SERVICE BULLETIN

NACELLE - POWER PLANT - HOIST POINTS - BLANKING PLUGS - INSTALLATION OF - CATEGORY
CODE 4 - MOD.NAC-71-0016

V2500-NAC-71-0016

Installation of a Blanking Plug to the Inlet Cowl Hoist Points
Fig.1

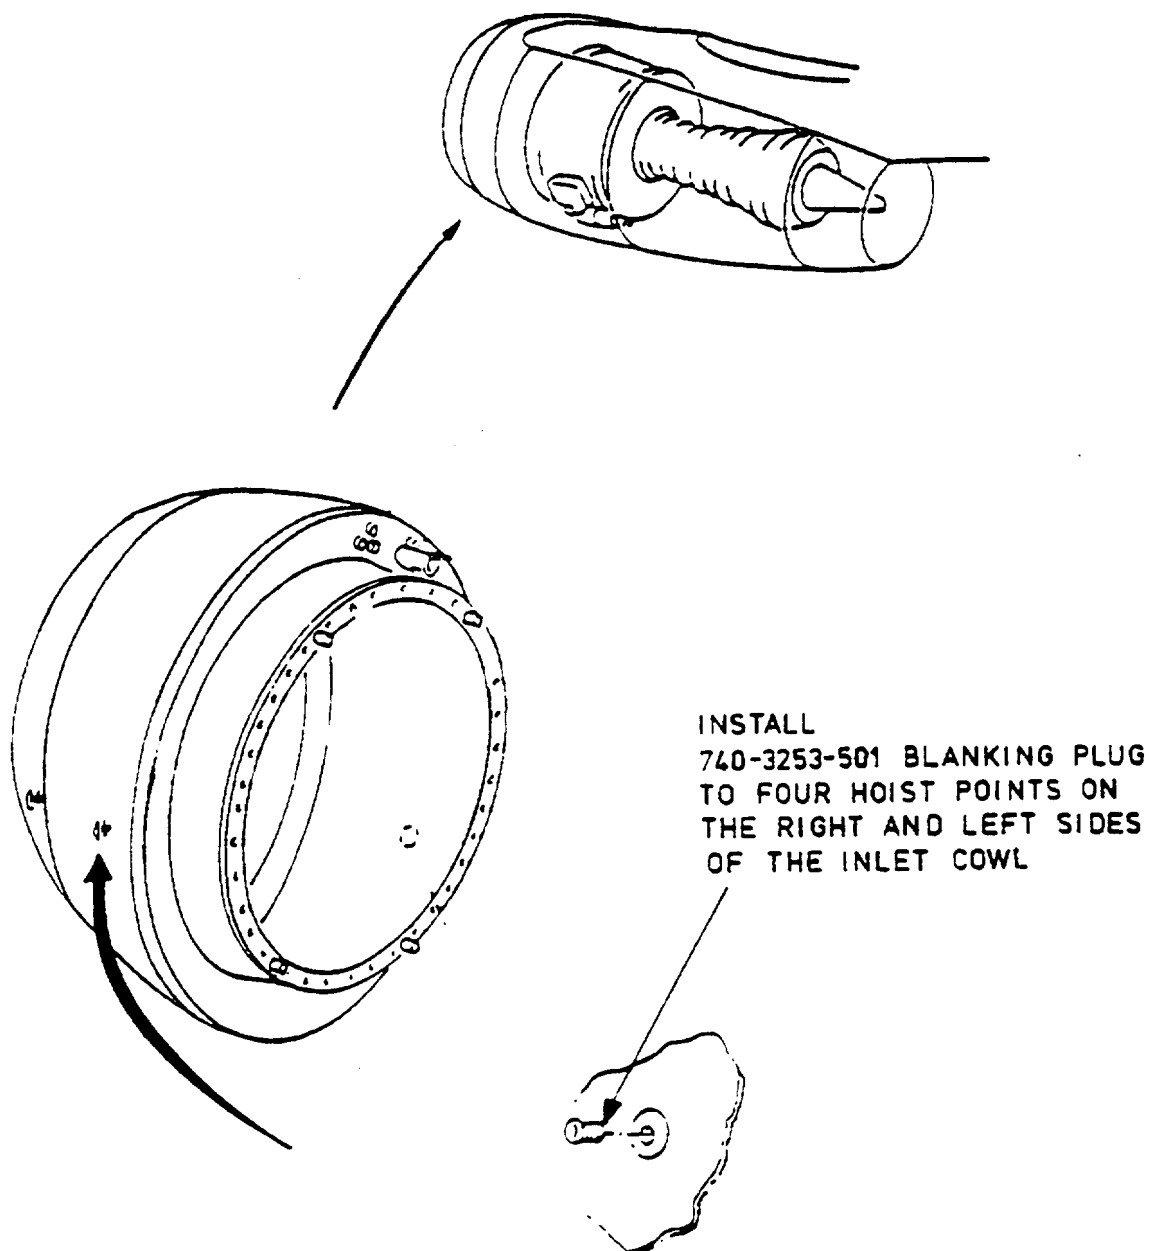
Any debris is removed from the eight hoist points on the inlet cowl and fan cowl. Four 740-3253-501 blanking plugs are installed in the inlet cowl hoist points; four 740-4116-501 blanking plugs are installed in the hoist points on the fan cowl doors.

- (1) Find the four hoist points on the right and left sides of the inlet cowl. (Refer to Figure 1.)
- (2) Remove any unwanted material from inside the hoist points and install a 740-3253-501 blanking plug in each hoist point.
- (3) Find the four hoist points on the right and left fan cowl doors. (Refer to Figure 2.)
- (4) Remove any unwanted material from inside the hoist points and install a 740-4116-501 blanking plug in each hoist point.
